FIELD CHANGE ORDER NUMBER: KA43-0001

APPLICABILITY: This FCO is for the VAXstation 3100, Model 76 only.

SOLUTION: Replace KA43 System Module.

CHECKING THE KA43 SYSTEM MODULE

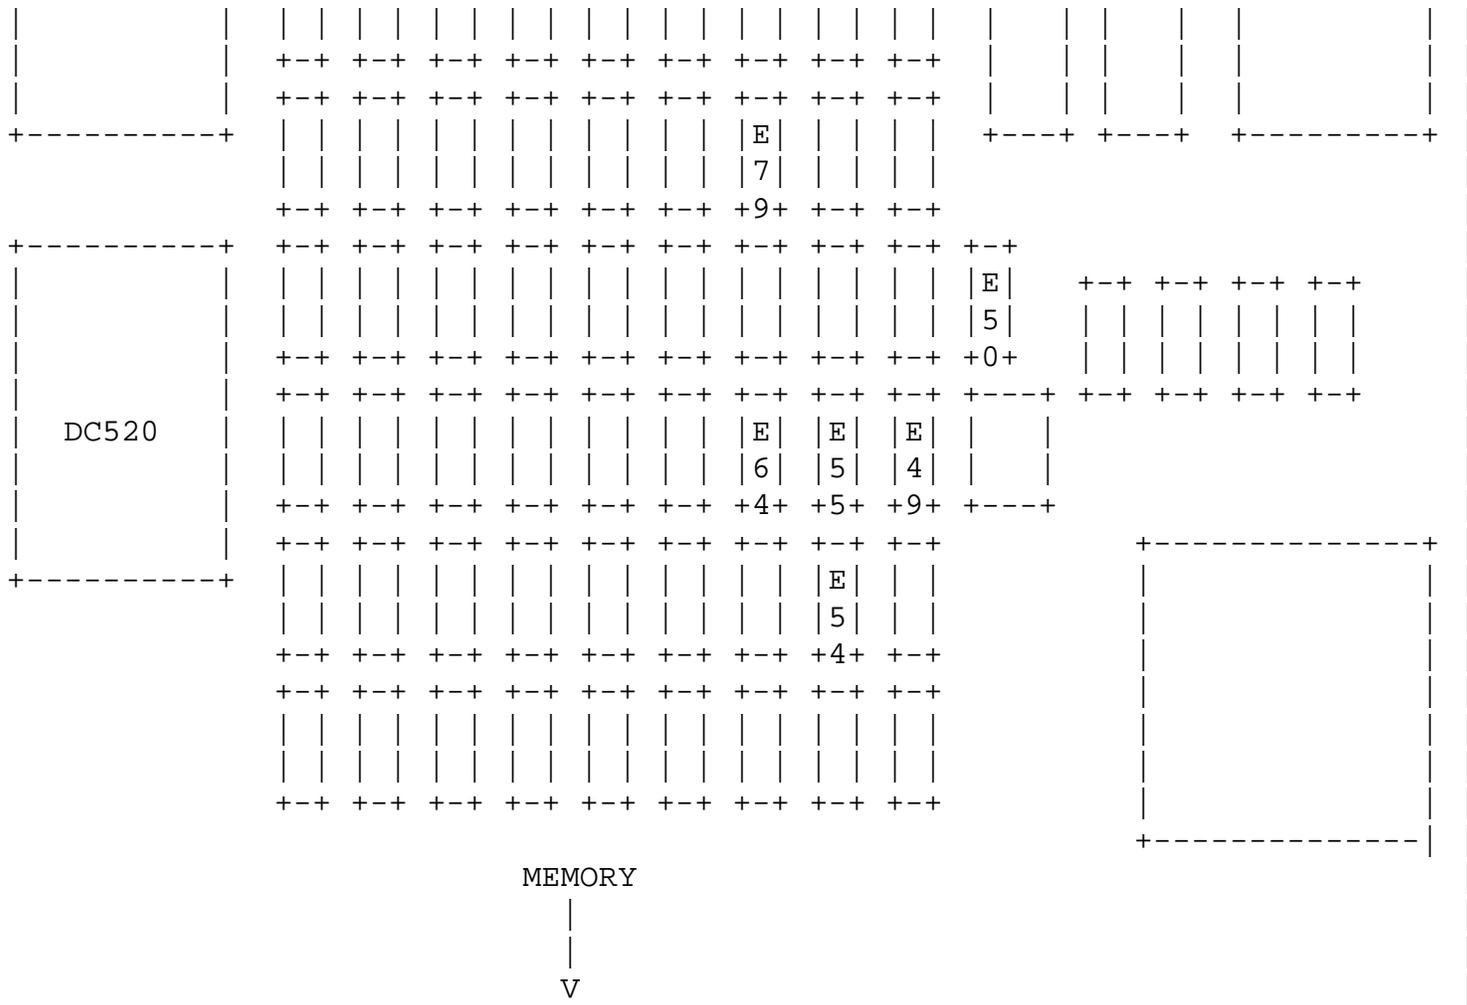
Using the diagram on the following page check the the devices at locations E49, E50, E54, E55, E64 and E79. These are 74F244 chips. First check to see if any of the six chips are made by National Semiconductor. If none of these chips are made by National Semiconductor the CPU module does not need to be replaced and you may put the system back together. If any of
